Project	IEEE 802.16 Broadband Wireless Access Working Group < <a href="http://ieee802.org/16">http://ieee802.org/16</a> >	
Title	Improved CTC Performance	
Date Submitted	2005-01- <del>1025</del>	
Source(s)	T. Keith Blankenship Yufei Blankenship Brian Classon Motorola	keith.blankenship@motorola.com yufei.blankenship@motorola.com brian.classon@motorola.com
	<a href="#">Alek Purkovic</a> <a href="#">Nortel Networks</a>	<a href="mailto:apurkovi@nortelnetworks.com">apurkovi@nortelnetworks.com</a>
Re:	IEEE P802.16-REVe/D5a, BRC recirc	
Abstract	This contribution demonstrates that the convolutional turbo code (CTC) interleavers for block sizes 120 bytes and above have performance deficiencies. By selecting different interleaver parameters for these block sizes, the deficiencies can be corrected. The performance improvement in AWGN at $10^{-4}$ FER with the new parameters is at least 0.5 dB and in some cases up to 1.3 dB.

Purpose	To provide improved CTC channel coding interleaver parameters when supporting H-ARQ with 802.16e units.	
Notice	This document has been prepared to assist IEEE 802.16. It is offered as a basis for discussion and is not binding on the contributing individual(s) or

Figure 2. Performance with new CTC interleaver parameters.

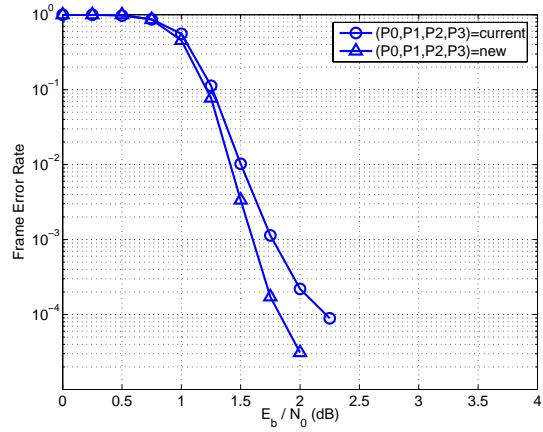
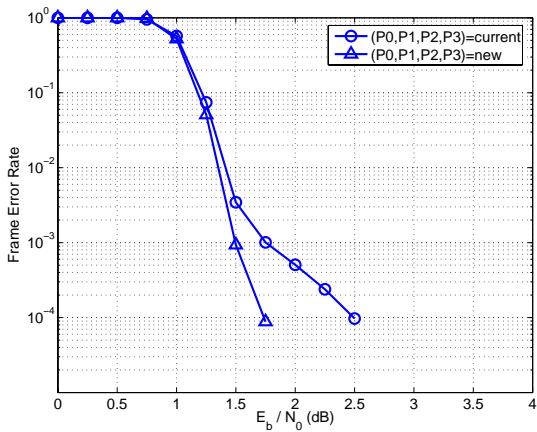
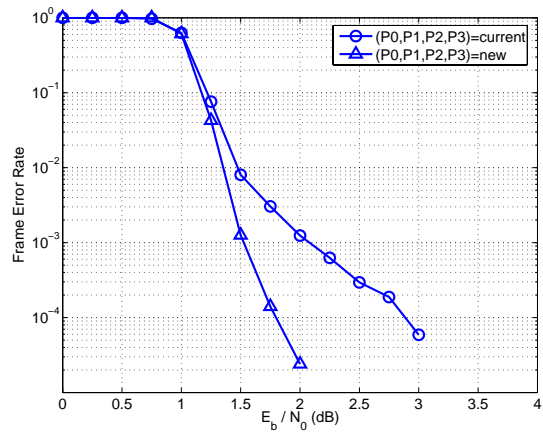
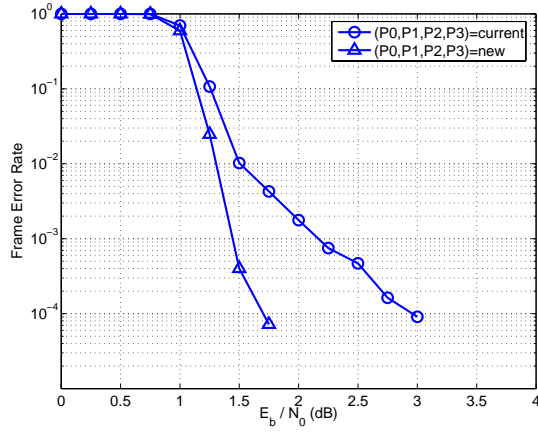
A new set of CTC interleaver parameters was designed to correct the performance deficiencies of the  $120n$ -byte block sizes. The new parameters were selected according to guidelines prescribed in [1]. The FER performance (rate-1/2, binary modulation, static AWGN channel, 7.5 decoding iterations, and “genie” circulation state knowledge) with the new parameters is plotted in Figure 2. The figure shows that the new parameters correct the performance deficiencies of the current parameters. At FER =  $10^{-4}$  the performance with the new parameters is at least 0.5 dB and in some cases up to 1.3 dB better than with the current parameters.

Figure 3. Cross simulation provided by Nortel on the existing and new CTC interleaver parameters.

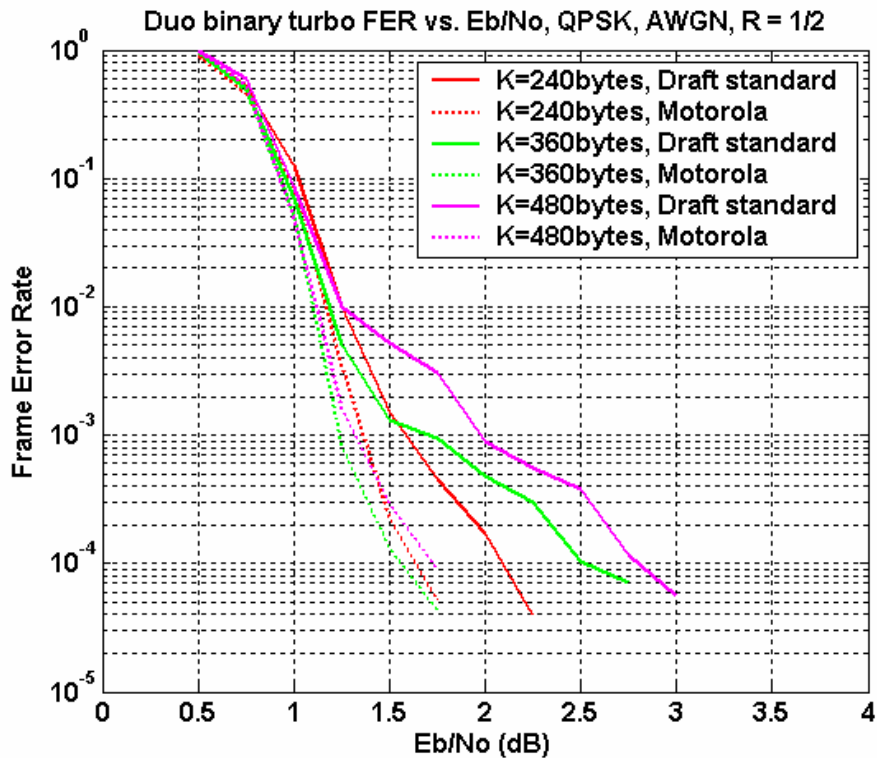
The proposed interleaver parameters have been independently tested by Nortel in comparison to the existing parameters. Their results in Figure 3 further support the significant improvement achieved by the proposed parameters.
